# Wollongong Local Planning Panel Assessment Report | 7 June 2022

<b>WLPP No.</b>	Item No.5
<b>DA No.</b>	DA-2021/1297
<b>Proposal</b>	Residential - demolition of existing dwellings, construction of a four (4) storey residential flat building with twenty three (23) units and attached thirty eight (38) room boarding house over basement parking
<b>Property</b>	23 & 27-31 High Street, Corrimal
<b>Applicant</b>	Design Workshop Australia
<b>Responsible Team</b>	Development Assessment and Certification - City Centre Major Development Team (NL)
<b>Prior WLPP meeting</b>	N/A

## ASSESSMENT REPORT AND RECOMMENDATION

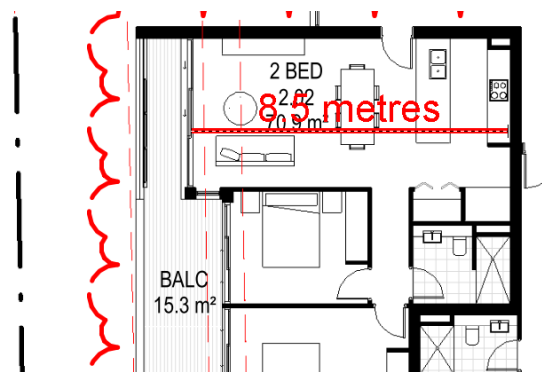
Concern	Comment
the kerb edge, and generous footpaths with native planting beside to property boundary.	
Along the street, but internal of the site boundary, the proposed lawn would be better replaced with low planting as it provides little to no amenity but does add to ongoing maintenance.	This matter has been generally addressed or could be resolved via conditions.
The southern boundary shows significant tree planting however there appears to be inadequate soil width and volume in this location to achieve this. Coordination between disciplines needs to be undertaken to provide a wider soil zone that can sustain proposed tree growth.	
The location of the RFB's COS entry location should be reconsidered; it may be better located immediately south of the fire stair to provide access more central to the COS, and to avoid accidental views into apartments opposite.	This has been addressed.
The layout of the RFB's COS is dominated by circulation and scattered seating. Further design work should be undertaken to provide spaces programmed for a variety of uses suitable to the expected future tenants. Planters could be arranged to create a series of rooms as opposed to corridors. The potential to use the buildings walls, and introduce thresholds, to create these spaces should be explored.	This has not changed significantly as illustrated below.

<p>Original</p>  <p>Amended</p> 
The lawn to the edge of both the RFB and boarding house spaces allows informal seating (a potentially good inclusion) however the resolution means that overly shaded, unusably narrow, and oddly arranged spaces, result (e.g., planter or seat directly beside narrow strip of	Generally unchanged

COS ANALYSIS - SHADOWS - JUNE 12noon

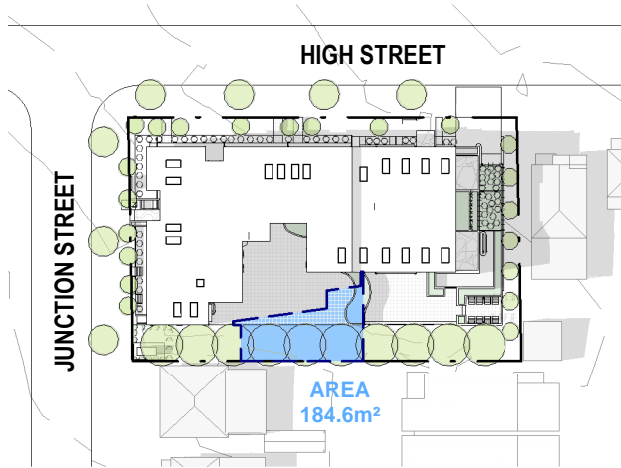
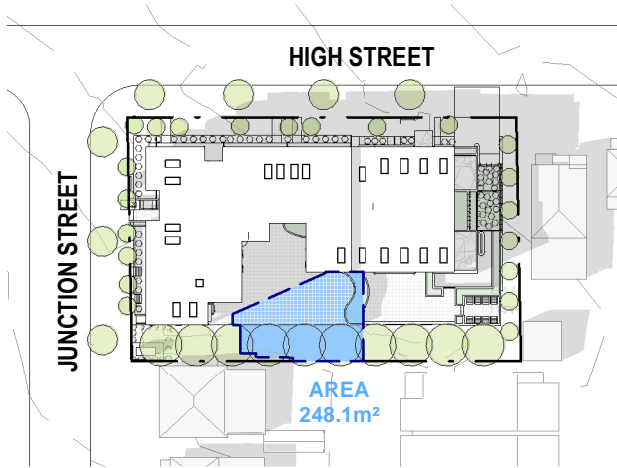
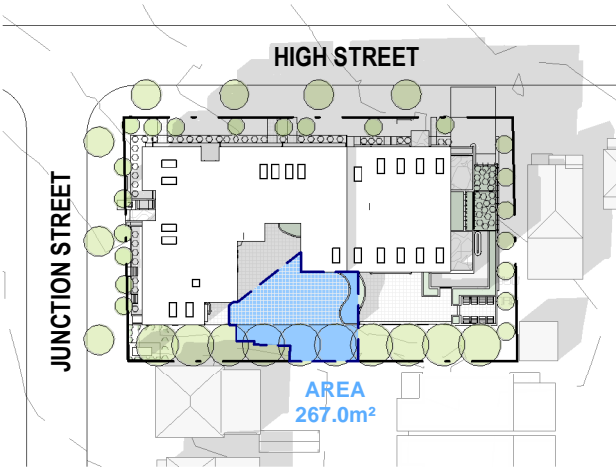
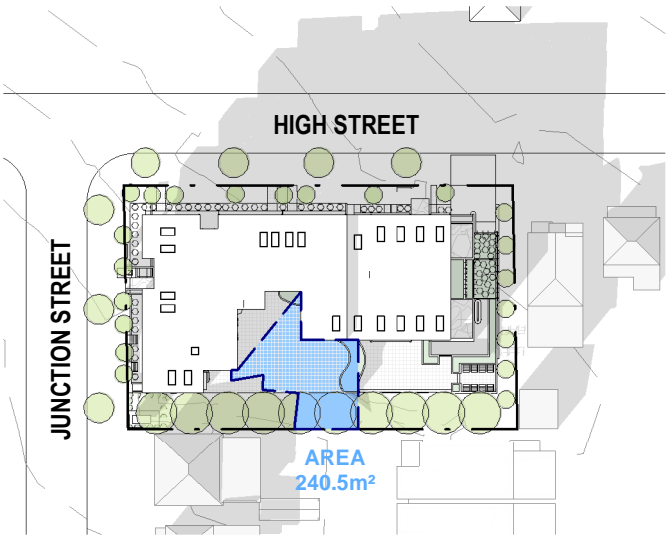
- The communal living room should receive a minimum of 3 hours direct sunlight between 9am and 3pm on 22 June. The pergola structure adjacent this space would seem to prevent this being achieved.
- Subdivision or community title subdivision of boarding houses is prohibited. The application includes a proposed strata subdivision plan.
- The proposal does not detail the key objectives of the boarding house. (i.e., Is it consistent with localised housing needs and demands? Does it increase housing stock? Will it provide affordable options? Who will it accommodate? Is it for a special needs group, providing housing for groups otherwise disadvantaged or providing wider social benefit?)
